**METROPOLITAN GOVERNMENT OF NASHVILLE AND DAVIDSON COUNTY**

**STAFF RECOMMENDATION**  
**1802 Lakehurst Drive**  
**August 21, 2013**

**Application:** New construction-infill  
**District:** Lockeland Springs-East End Neighborhood Conservation Zoning Overlay  
**Council District:** 06  
**Map and Parcel Number:** 08310046000  
**Applicant:** David Baird, architect  
**Project Lead:** Robin Zeigler, robin.zeigler@nashville.gov

1809 Lakehurst Drive is an example of a home in Little Hollywood that has a front garage.

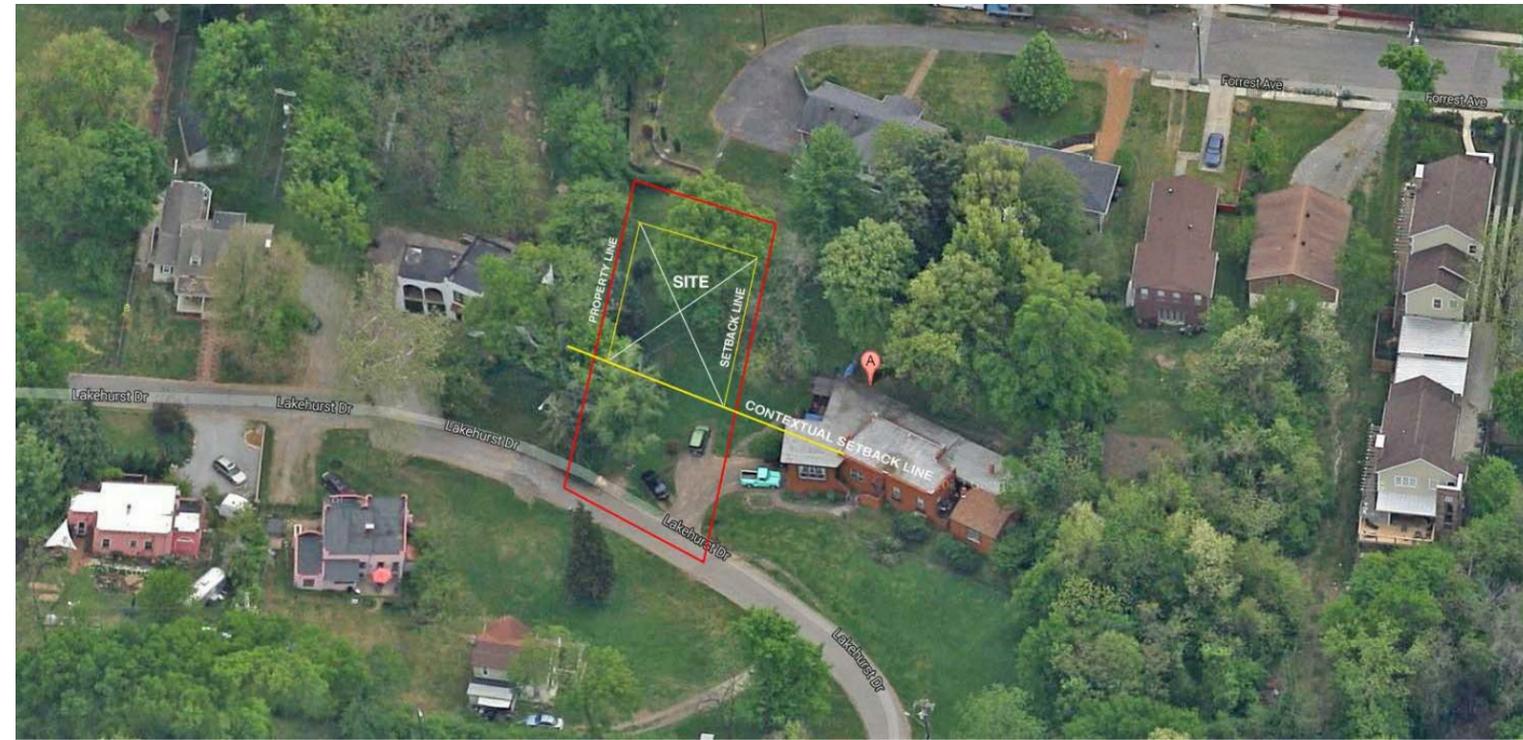
The garage doors of the proposed are also oriented towards the street with a shared driveway on the right side of the lot. Several of the historic homes in the neighborhood have single-garages on the front of the house, at the basement level. In order to mitigate the larger size of modern garage openings and the fact that the proposed garage has two bays rather than just one, the garage doors are set at an angle from the massing of the front wall. A new curb cut is not needed as the driveway will be a reconstructed driveway that will be shared with the house to the right. The width of the shared driveway is approximately twenty feet (20') at the street. The project meets section II.B.6 and II.B.8.
